# The Long Beach - Los Angeles Rail Transit Project

# Final Environmental Impact Report

(SCH No. 83091415)

### **Parsons Brinckerhoff / Kaiser Engineers in Association With:**

REVISED  
 Figure II-22A

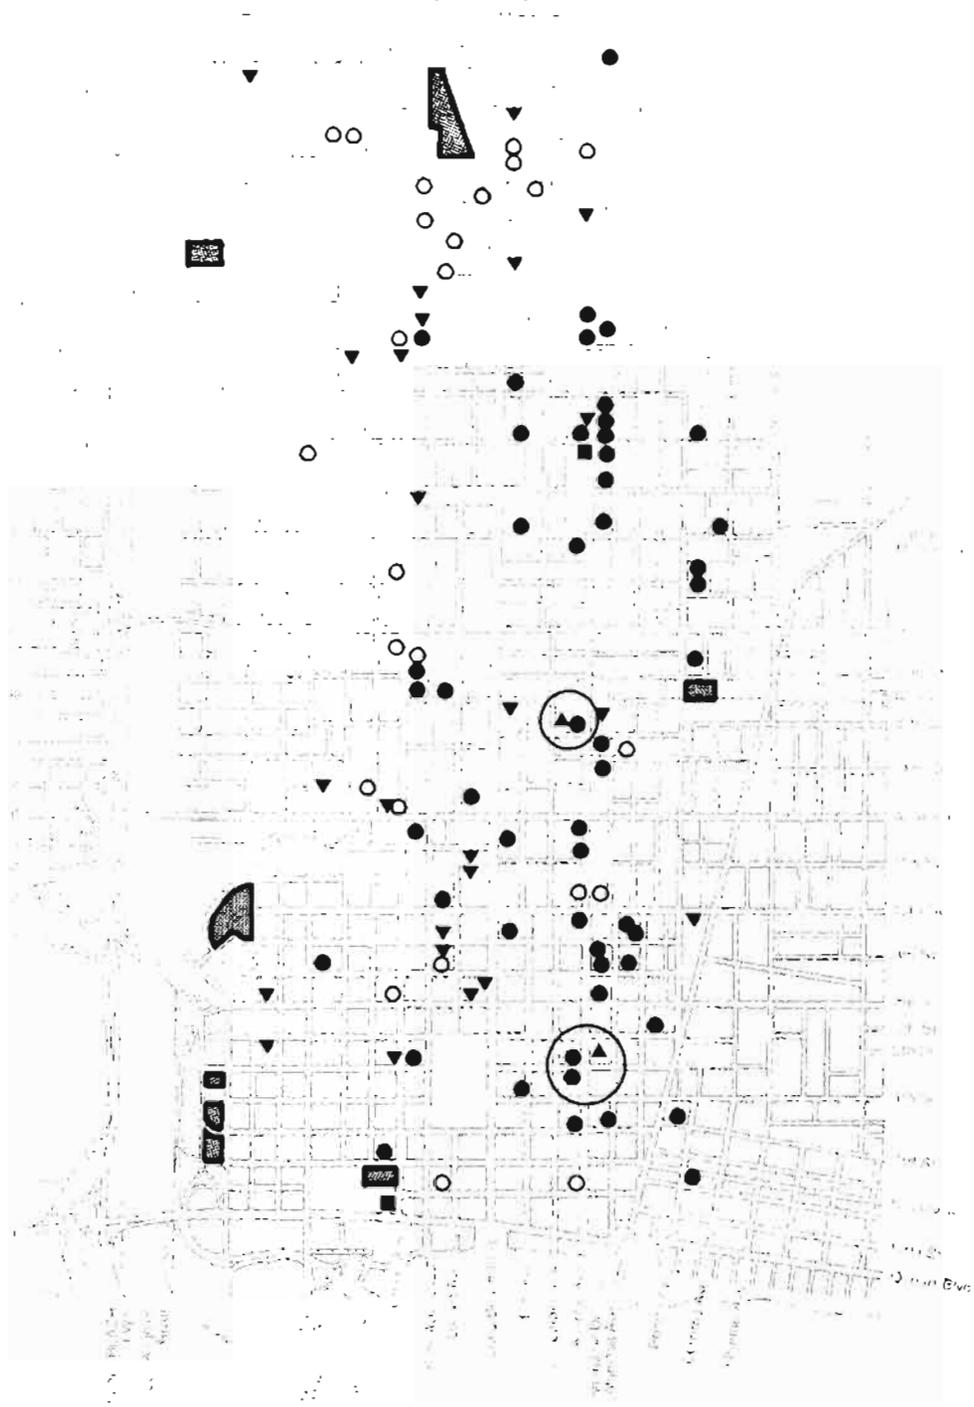
Figure 42-B shows an incorrect placement of one of the schools, thereby implying no impact. (LBPTA)

On page II-123, Figure II-42B, the placement of schools and churches is herewith corrected and the replacement Figure II-42B is reprinted on page III-176. The circled areas contain changes in the locations of schools and churches.

REVISED Figure IV-15A

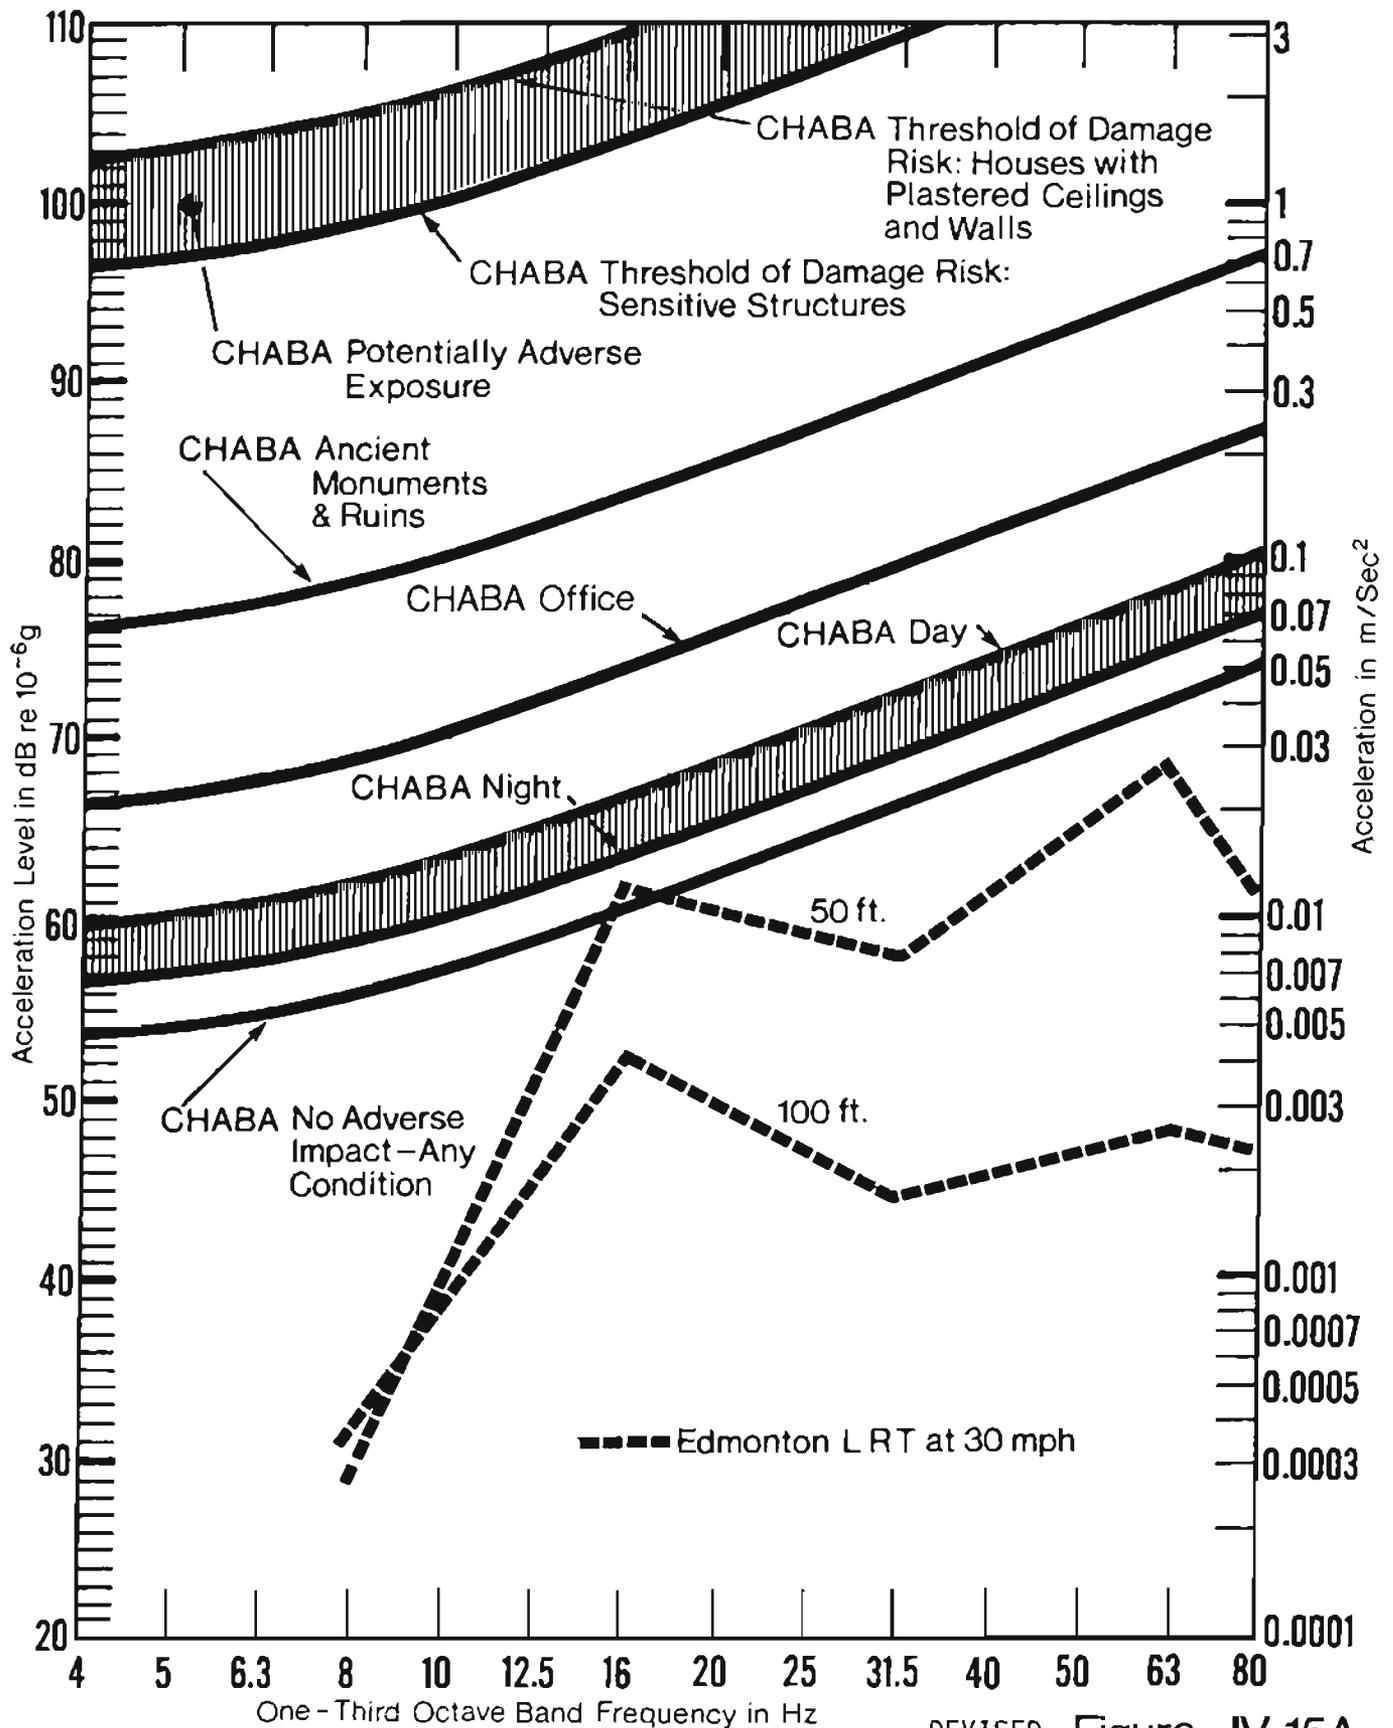
On page IV-10, the discussion of vibration addresses development at distances of 50 feet and 100 feet from the transit line, but does not deal with a situation wherein the transit line is integrated into a development, such as proposed in one of the variations of the river route at the World Trade Center. This section of the EIR should be enlarged to discuss this potential adverse impact and to propose any necessary mitigation measures. (Long Beach)

The accompanying figure is a reproduction of Figure IV-15A from the Supplemental EIR, with one additional curve labeled "CHABA Office." (The curves labeled "CHABA Day" and "CHABA Night" refer to daytime and nighttime vibration criteria for residential uses, while the "CHABA Office" curve refers to vibration criteria for office and/or commercial use.) The figure also shows measured vibration levels at two distances from the Edmonton
